A D D E N D U M

ADDENDUM TO REPORT OF DUNCAN MITCHELL, DIRECTOR ENGINEERING & PROPERTY SERVICES DATED 23 MARCH 2020

SUBJECT: Item 19 - North Sydney Olympic Pool Development Application Amendments Requested by the Independent Planner - Heritage Planners and Public Consultation Feedback

DATE: 3 April 2020

Figure 3a. View looking at the café roof and shade structure over the Children's swimming Pool. *Before* modification

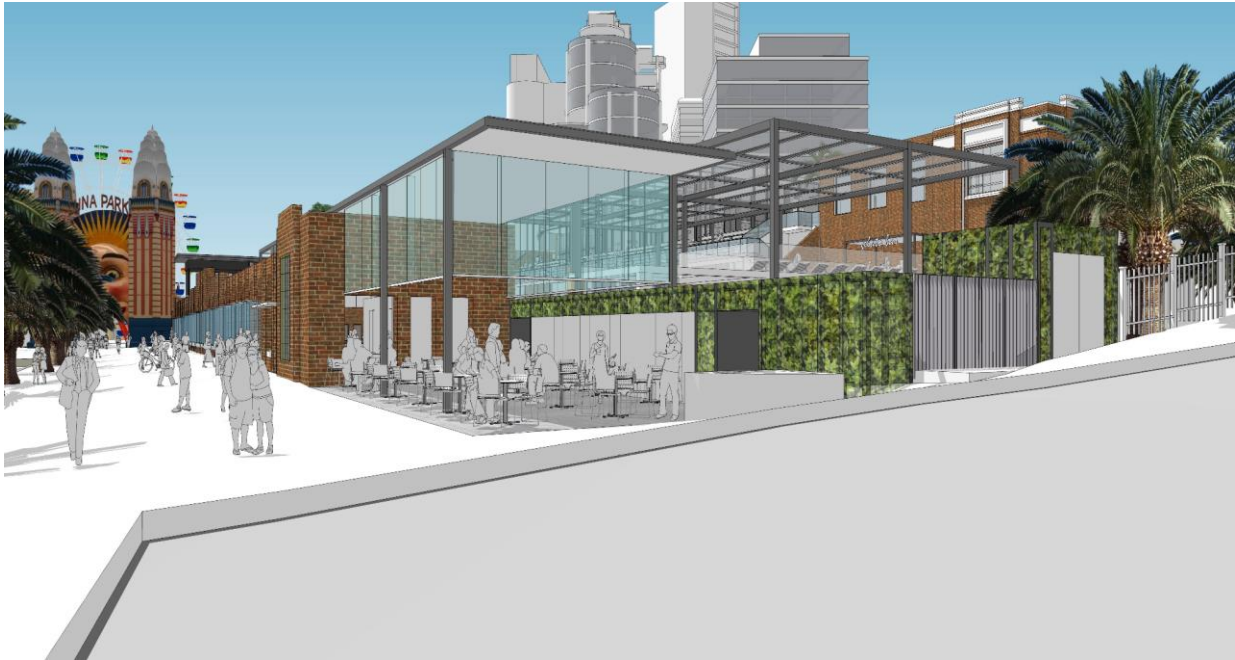
| Design Item | Change to DA 347/19 | Initial Assessment Comment |
|--------------------------------------------------------|---------------------------------------------------------------------------------------------------------------------------------------------------------------------------------------------------------------------------------------------------------------------------------------------------------------------------------------------------------------------------------------------------------------------------------------------------------------------------------------------------------------------------------------------------------|---------------------------------------------------------------------------------------------------------------------------------------------------------------------------------------------------------------------------------------------------------------------------------------------------------------------------------------------------------------------------------------------------------------------------------------------------------------------------------------------------------------------------------------------------------------------------------------------------------------------------------------------------------------------------------------------------------------------------------------------------------------------------------------------------------------------------------------------------------------------------------------------------------------------------------------------------------------------------------------------------------------------------------------------------------------------------------------------------------------------------------------------------------------------------------------------------------------------------------------------------------------------------------------------------------------|
| <p>3. Additions to south-eastern corner of complex</p> | <p>Brewster Hjorth Architects have modified their design to the cafe roof which has been redesigned to separate the outdoor seating area roof and the cafe internal area roof. Both roofs will be lowered below the parapet line.</p> <p>The brick parapet will be continued through from the reconstructed sundeck</p> <p>Note: The roof structure over the café had already been reduced in size and height – as a result of the pre-DA meeting feedback on 26 August 2019 and is reflected in the current Development Application design.</p> | <p>The independent Heritage Planner raised issues with the design of the eastern corner of the complex at both the Pre-Da meeting held 26 August 2019 and also in the initial assessment letter to Council received on the 19 March 2020.</p> <p>Comments from the independent Heritage Planners on the proposed additions to the eastern corner of the complex are as follows:</p> <p><i>Although reduced from the original pre-DA design, the proposed new roof over the cafe in the southeast corner is still excessively high and visually prominent. It is uncharacteristic to the complex, dominating the historic corner element, resulting in an adverse heritage impact. This impact is exacerbated by the additional visual impact of the adjacent roof of the children's pool.</i></p> <p><i>The element is located at a critical part of the complex when viewed from the public domain and harbour, and forms part of the setting of Luna Park.</i></p> <p><i>Council's heritage controls require that new works to heritage items should be submissive in scale, so as to not dominate the original built form. The height of the new roof to the cafe should be set to below the original southern perimeter wall and be designed to have minimal visual impact on the corner element.</i></p> |

Aerial view of the DA Design as seen from the Harbour Bridge

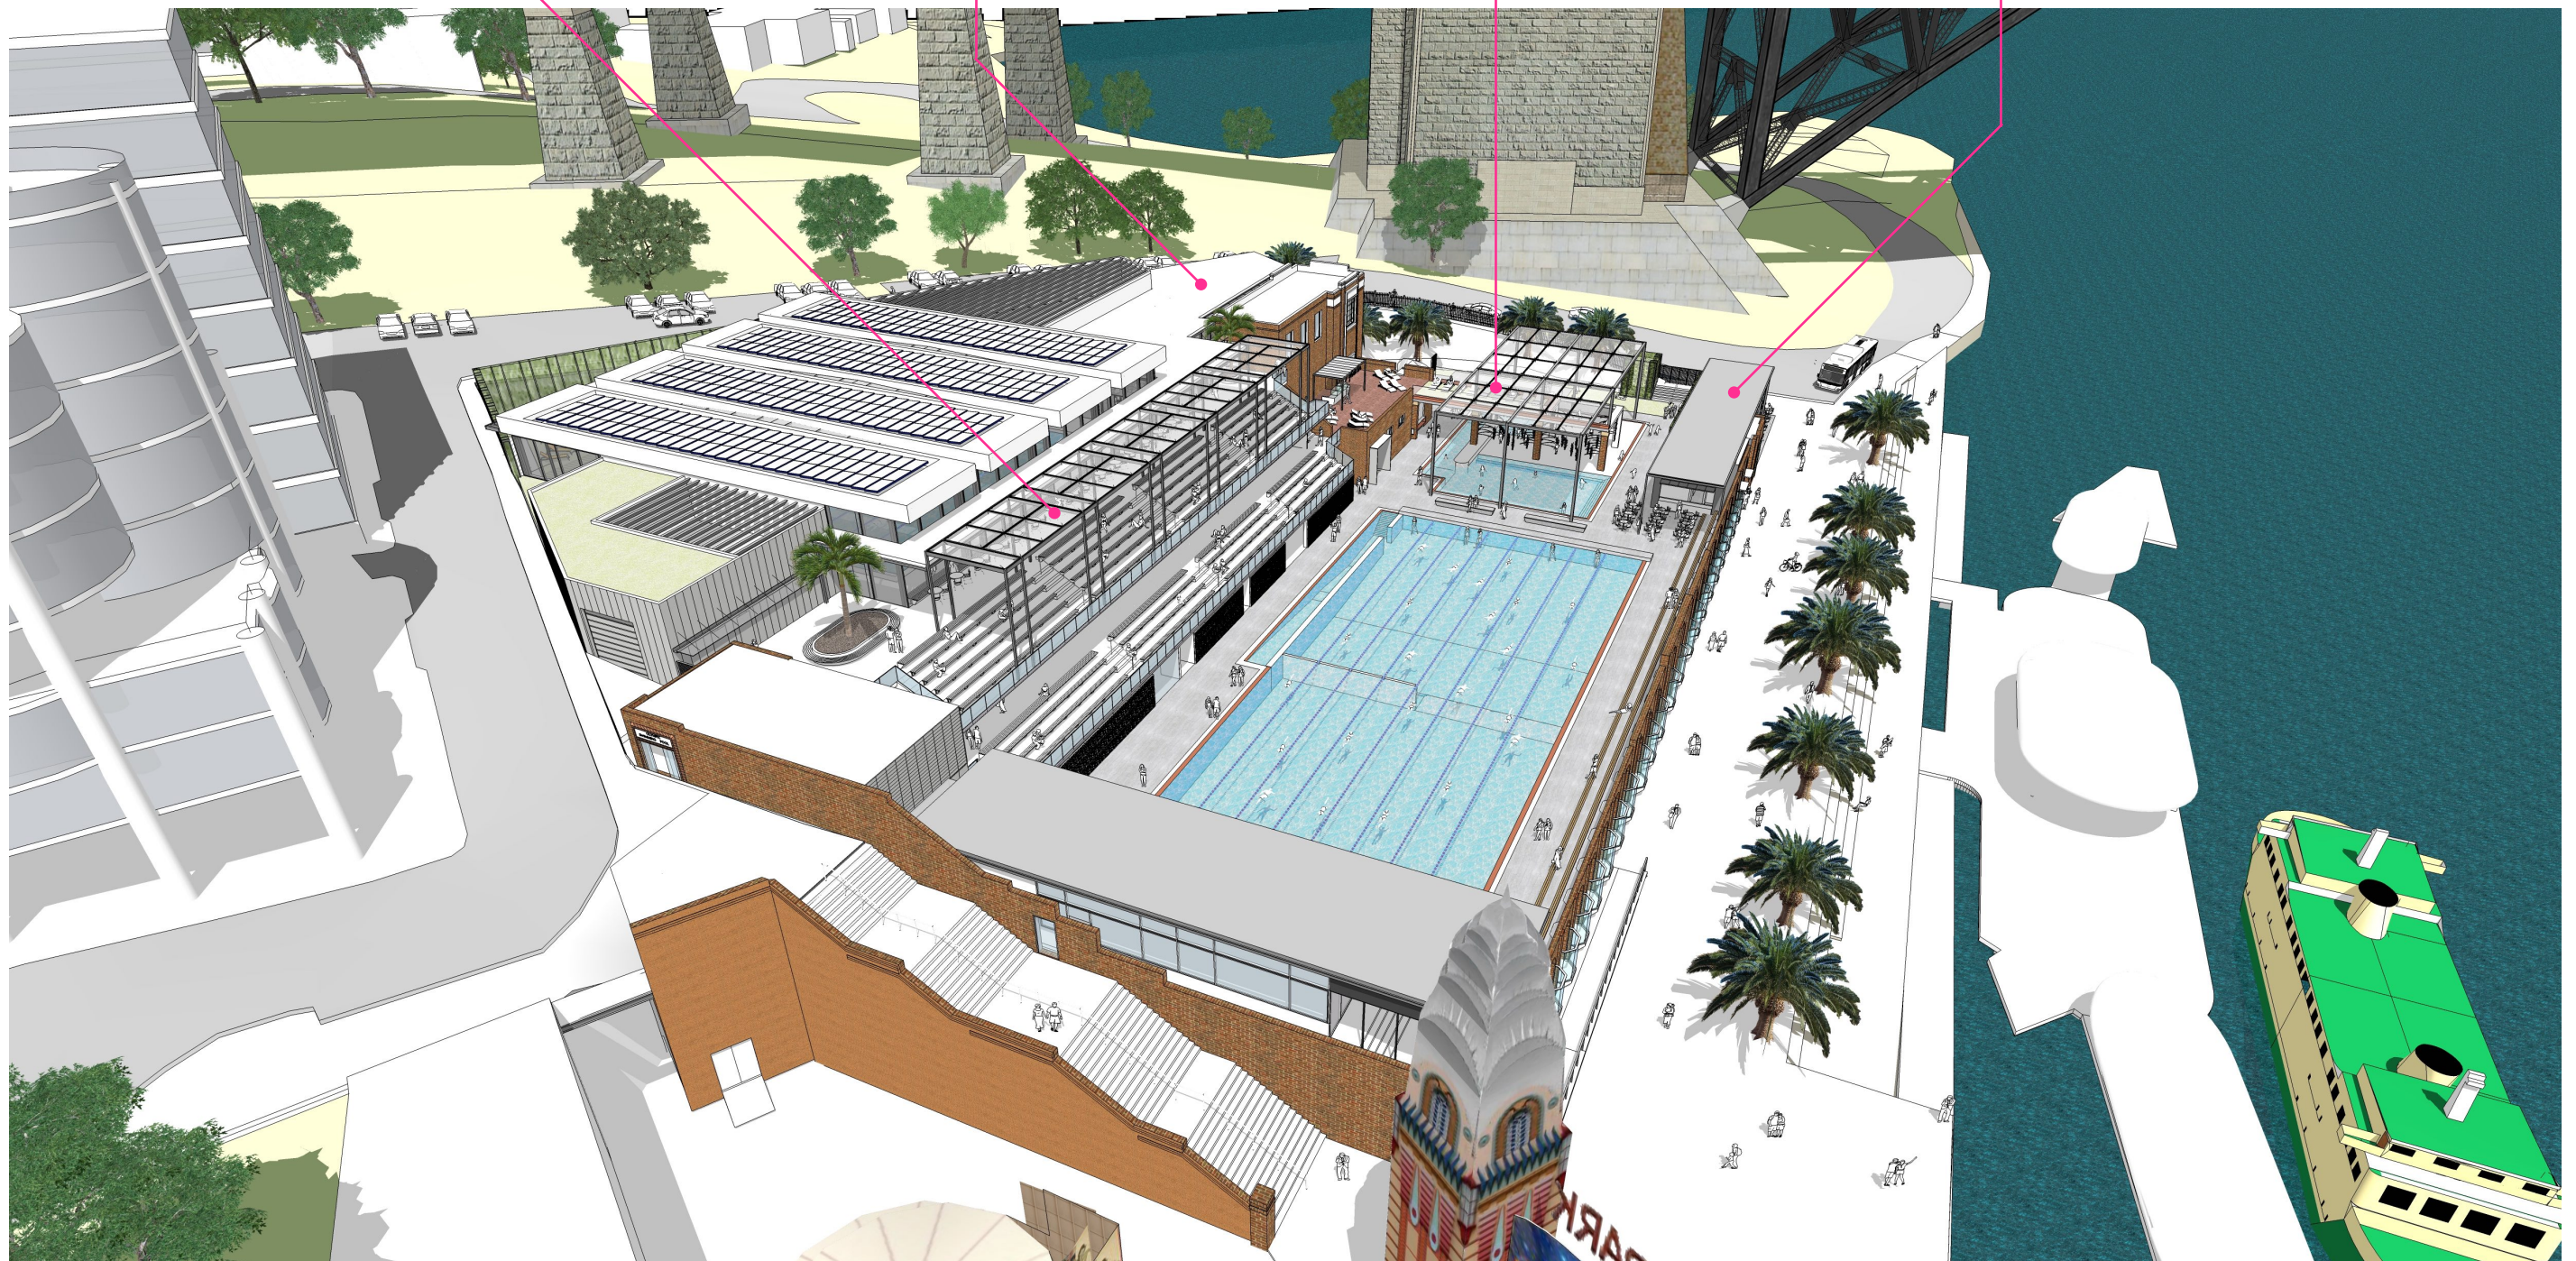
4 the Heritage Assessor feels that the proposed shade structure to the grandstand is too high, and visually dominant to the grandstand

5 Although it has been substantially reduced the Heritage Assessor feels that the proposed glazed foyer still dominates the brick heritage stair tower and original entry when viewed from Alfred Street

3 the Heritage Assessor feels that the proposed shade structure is too visually dominant to the sundeck, it should be lowered, or visually reduced in some way

1 the Heritage Assessor feels that the roof of New Ripples Cafe and outdoor dining area is too dominant to the heritage brickwork which forms the corner of the heritage perimeter wall

It was agreed in the meeting to reduce its height further to align with the walkway roof behind but to maintain its columns which were similar to the structure and size of the original grandstand roof

It was agreed in the meeting that the proposed sunshade screen element around the perimeter of the glazed lobby would be deleted. The assessor did not agree that this would satisfy their concerns

BHA have modified their design to remove the shade structure from the DA application.

It was agreed in the meeting that BHA would lower the roof below the existing brickwork parapet line

Aerial view of the DA Design as seen from above Luna Park

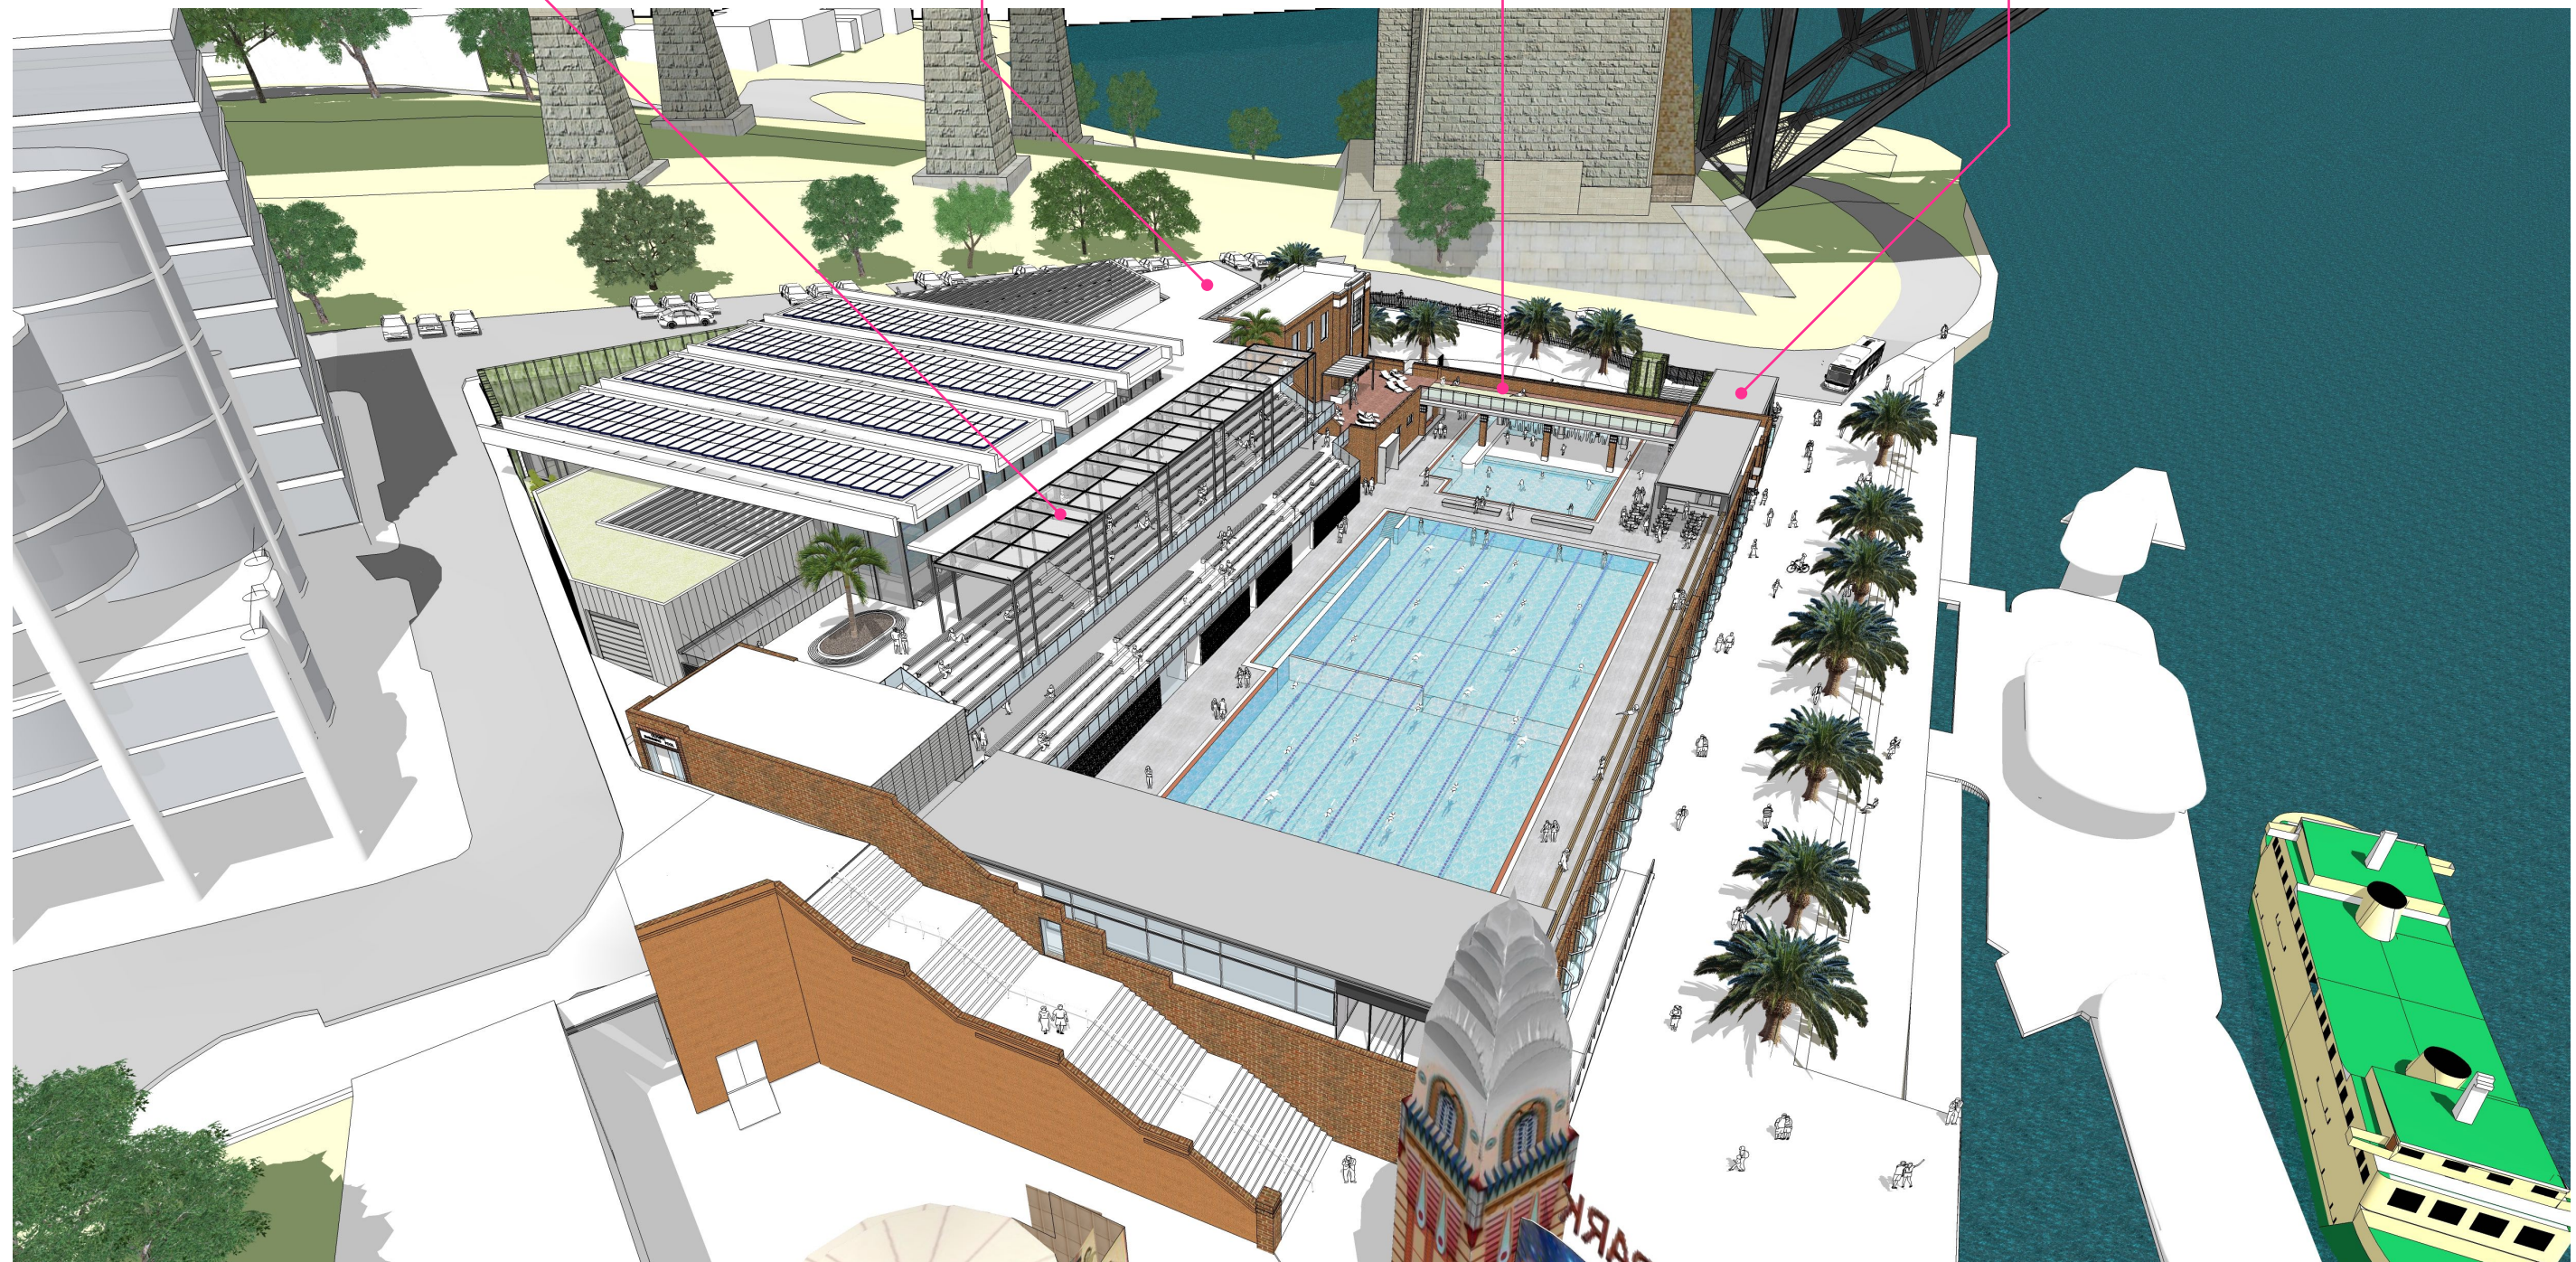
4 Grandstand Sunshade

5 New Foyer

2 The Sundeck

1 Ripples Cafe Roof

The height of the lightweight grandstand roof/ sunshade has been further reduced to align it with the walkway roof behind. its columns which were similar to the structure and size of the original grandstand roof are retained

We propose to substantially reduce the size of the Foyer by redesigning the entry flow to bypass the original entry portal. The new Foyer structure is set back from the heritage stair tower to allow a view of it from Alfred Street

The upper level amenities have been redesigned to allow the foyer layout to be altered and reduced in size. Some small changes to floor levels of landings inside the stair tower are proposed to allow the accessible entry to be redesigned

the existing Sundeck SE wall and parapet will be reconstructed. It will have openings which are similar to its existing openings constructed in the 1960's. The actual deck would be rebuilt in concrete with new finishes.

A new water play feature will be installed in 2 of the openings (as shown) to help interpret the extent of the original wall

The cafe roof has been redesigned to separate the outdoor seating area roof and the cafe internal area roof. Both roofs will be lowered below the parapet line. The brick parapet will be continued through from the reconstructed sundeck
